WHY ARE WE RECALLING THESE RIFLES

HOW TO DETERMINE IF YOUR RIFLE NEEDS THE RETROFIT

Figure 1: Hole present, rifle NOT recalled

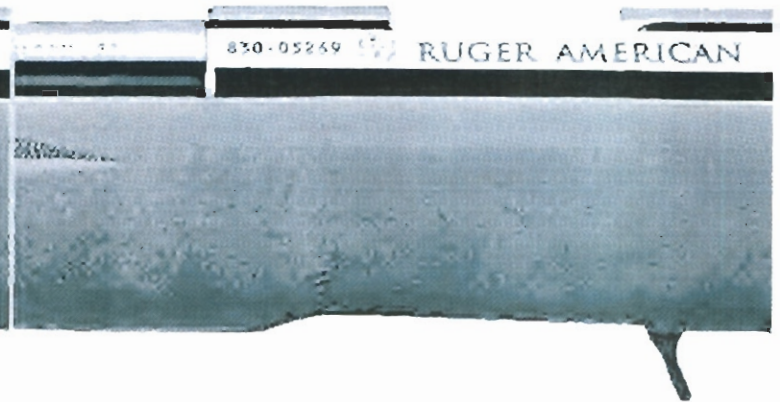
We have determined that Ruger American Rimfire® rifles chambered in .22 WMRF (Magnum) and .17 HMR manufactured between November 17, 2013 and January 8, 2014 were manufactured without a vent hole. This hole appears just below and behind the serial number on the left-hand side of the receiver. The hole does not serve any function during normal operation of the rifle, but is a safety feature and may help vent gas in the event of a problem such as a ruptured case head or bore obstruction, for example. We want to recall the rifles and add the vent hole.

First, only Ruger American Rimfire® rifles chambered in .22 WMRF (Magnum) and .17 HMR within the serial number range 830-04830 to 830-48830 are subject to the recall. **IF YOUR RIFLE IS CHAMBERED IN .22 LR OR FALLS OUTSIDE OF THIS SERIAL NUMBER RANGE, IT IS NOT SUBJECT TO THE RECALL.** If you do have an Ruger American Rimfire® rifle chambered in .22 WMRF (Magnum) or .17 HMR, you need only examine the left side of the receiver just below and behind the serial number. If there is a hole there (Figure 1), then you do not need to return the rifle. If there is no hole (Figure 2), then the rifle should be returned.

Although we have not had any reported incidents involving the rifle and it is perfectly safe during normal operation, we discovered that the rifle was manufactured without a vent hole that was part of the design. The vent hole does not serve any function during normal operation, but may help relieve pressure in the event of a ruptured case head or bore obstruction, for example.

We would like to arrange return of the rifle to have the vent hole machined into your rifle. We will pay all costs of shipping and will return the rifle to you within a week of the device shipped to Ruger.
